TOWN OF KITTELY

Planning Board Meeting January 25, 2024

ITEM 3 – 77 Bartlett Road – Conservation Subdivision Plan – Final Review

DATE: 5/18/2023
SCALE: 1" = 20'
DESIGNED: MTW
JOB NO.: 22-145
SHEET: C-3.2

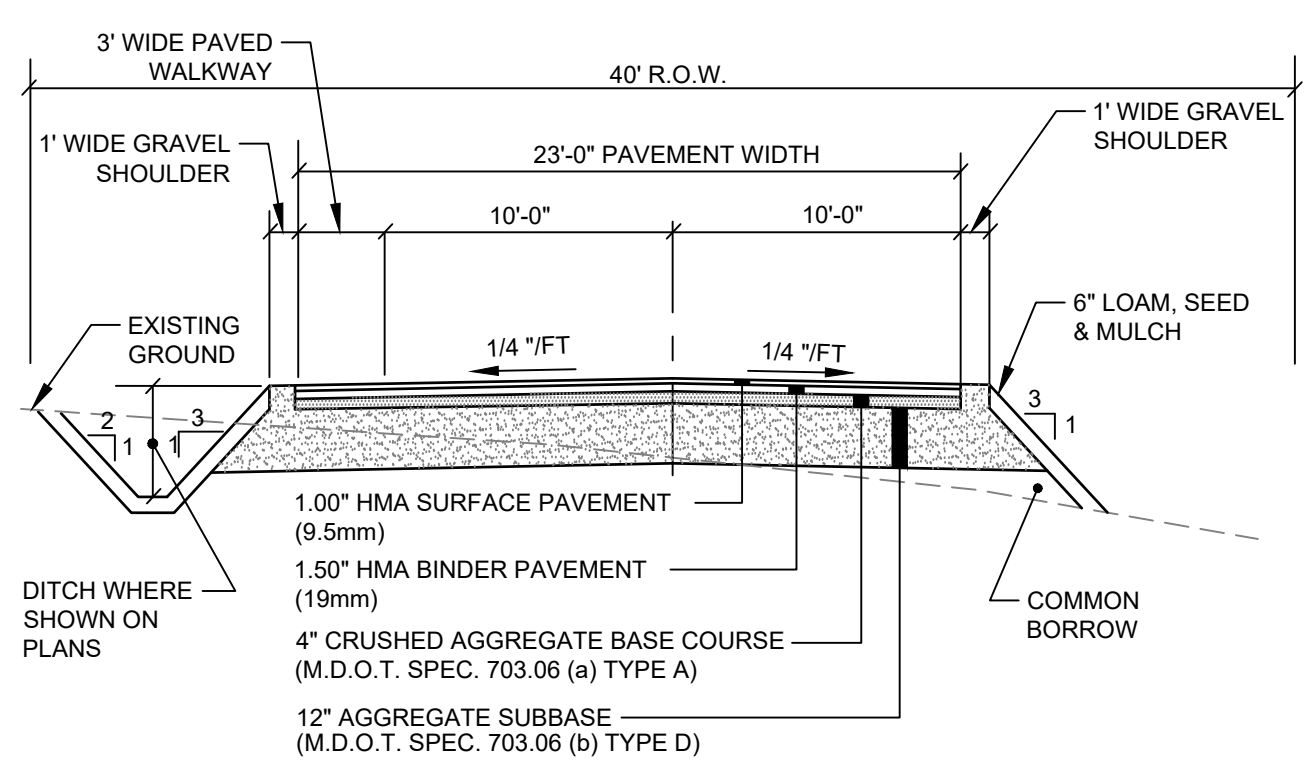
5. Following feedback from the public hearing, the applicant now shows plans to revegetate the existing driveway when removed.
6. Because the conservation subdivision ordinance strongly recommends all buildings within the subdivision be designed for maximum energy efficiency per **§16.10.6.A.(4)**, it is suggested that buildings be designed as south-facing whenever possible in this subdivision.

3. Sheet C-3.2 has been added to the plan set and shows the following information:
 - Proposed plant species and locations for the revegetation of the existing driveway have been specified by landscape architect Anthony Muench. Native species will be planted and are intended to "re-forest" the area and further buffer the open water wetland located at the southern boundary of the site.
